REMARKS

Claims 1-4, 6-15, 17-23, and 25-27 are currently pending in this application. Claims 5, 16, and 24, previously withdrawn, are hereby canceled without prejudice to or disclaimer of the subject matter therein. Claims 26 and 27 are new. Each of the previously pending claims (1-4, 6-15, 17-23, and 25) stand rejected in the September 10, 2003, Office Action.

Fig. 16

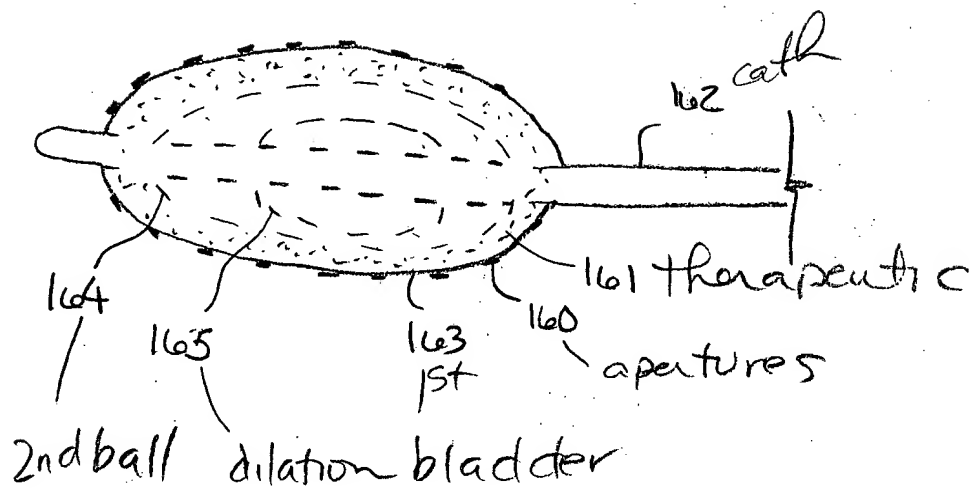
The drawings are also objected to for allegedly failing to show a “a second balloon positioned between the dilation bladder and the first balloon.” The undersigned submits that new Figure 16, which is Figure 13 redrawn to show a dilation bladder 165, a first balloon 163, orifices 160, and a second balloon 164, clearly shows the second balloon 164 inside the first balloon 163 and on top of the dilation bladder 165. Figure 16 does not represent new matter because support for it can at least be found in the specification’s discussion of Figures 12-14, the figures themselves, and in as-filed claim 18, which notes that a second balloon may be positioned between the dilation bladder and the first balloon. Consequently, entry of Figure 16 is requested.
